Access Compliance Report

Public Rights-of-Way

(Curb Ramps)

Intersection ID: 21002	Main Street: HANSON_RD	Cross Street: MICROSOFT_WY	Location: W
ADA ID: AEAC25292BB3	Ramp Type: Directional1	Initial Pass/Fail: Fail	Overall Compliance: No
		Severity Score: 37.5

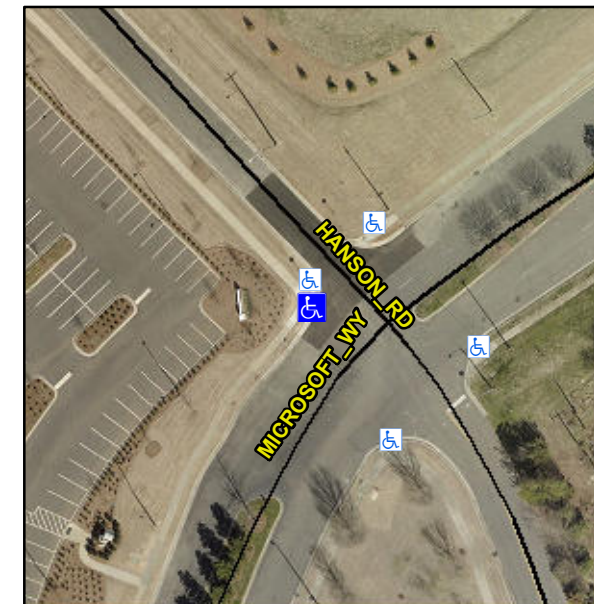
AERIAL OUTDATED

R304.2.2, R304.5.3

Compliance	Description	Data	Compliance	Description	Data
N/A	Ramp Length (in)	48.0	N/A	Grade Break?	N/A
Yes	Ramp Width (in)	50.0	N/A	Grade Break Slope (%)	0.0
No	Ramp Slope (%)	10.7	N/A	Grade Break XSlope (%)	0.0
No	Ramp XSlope (%)	7.5			
N/A	Flare Type LT	N/A	N/A	Flare Type RT	N/A
N/A	Flare Slope LT (%)	N/A	N/A	Flare Slope RT (%)	0.0
N/A	Flare Traversable LT?	N/A	N/A	Flare Traversable RT?	N/A
N/A	Landing Length (in)	0.0	N/A	DWS Provided?	N/A
N/A	Landing Width (in)	0.0	N/A	DWS Contrast?	N/A
N/A	Landing Slope (%)	0.0	N/A	DWS Length (in)	N/A
N/A	Landing X Slope (%)	0.0	N/A	DWS Full Width?	N/A
N/A	Landing Curb? (Y/N)	N/A	N/A	DWS Offset LT (in)	N/A
N/A	Shared Landing?	N/A	N/A	DWS Offset RT (in)	N/A
N/A	Gutter Ponding?	0.0	N/A	Gutter Slope (%)	N/A
N/A	Gutter Lip Ht (in)	0.0	N/A	Gutter X Slope (%)	N/A
N/A	Painted X Walk1?	No		Road Slope (%)	1.3
	X Walk 1 Direction	To SE		Road X Slope (%)	0.4
	X Walk 1 Width (in)	N/A		Clear Space?	N/A

Remove & Replace Entire Ramp.
